# Camden Council Business Paper

# Ordinary Council Meeting 27 February 2018

# SUBJECT:DRAFT SUBMISSION ON PROPOSED GLEDSWOOD HILLS PUBLIC<br/>PRIMARY SCHOOL - C THE HERMITAGE WAY, GLEDSWOOD HILLSFROM:Director Planning and EnvironmentTRIM #:18/27280

#### The aforementioned amendments are shown in the marked-up plan below:

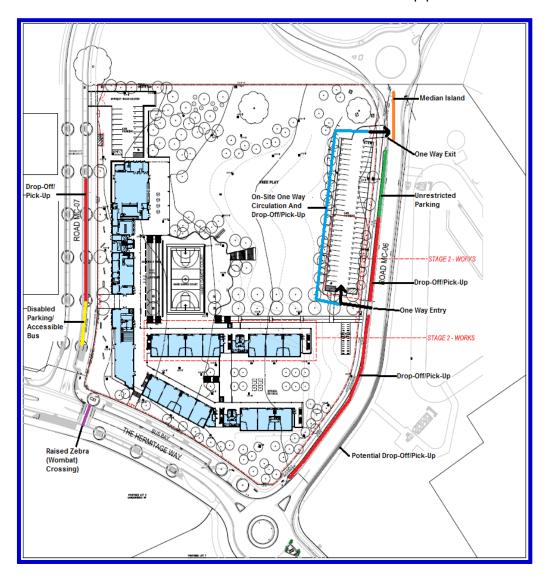
1. Following consideration of the proposed plans and traffic report, the following amendments to the proposed development are recommended:

Council notes that 75 off-street car parking spaces are required for the school under the Camden Development Control Plan 2011 and that 75 spaces have been proposed. Council maintains that a separate off-street drop-off/pick-up area within the site should be provided. This was also requested in Council's response to the draft Secretary's Environment Assessment Requirements dated 3 May 2017.

It is recommended that an off-street drop-off/pick-up area, including a one-way travel lane, is provided behind the car park off road MC-07. A pedestrian path should connect this area to the main pedestrian travel path through the site. The access to this car park should be modified to incorporate a one way entry/exit arrangement to facilitate the new drop-off/pick-up area.

Consequently it is recommended that an additional on street drop-off/pick-up area is formalised along road MC-07 to provide additional capacity nearer to the school buildings. It is also recommended to convert some of the drop-off/pick up area on road MC-06 past the pedestrian entry/exit gates to unrestricted parking.

There may be the potential to provide an additional on-street drop-off/pick-up area on the south eastern side of road MC-06. This should be considered, however any impact on the adjoining public open space would need to be assessed against the requirements of the Gledswood Hills Voluntary Planning Agreement.

All on-street car parking must be designed to comply with AS 2890.

The proposed accessible bus parking area on road MC-07 should be modified to be a general disabled car parking area that is available for both the accessible bus and disabled car parking. The accessible bus parking times should be staggered to ensure they do not conflict with general disabled parking for the school.
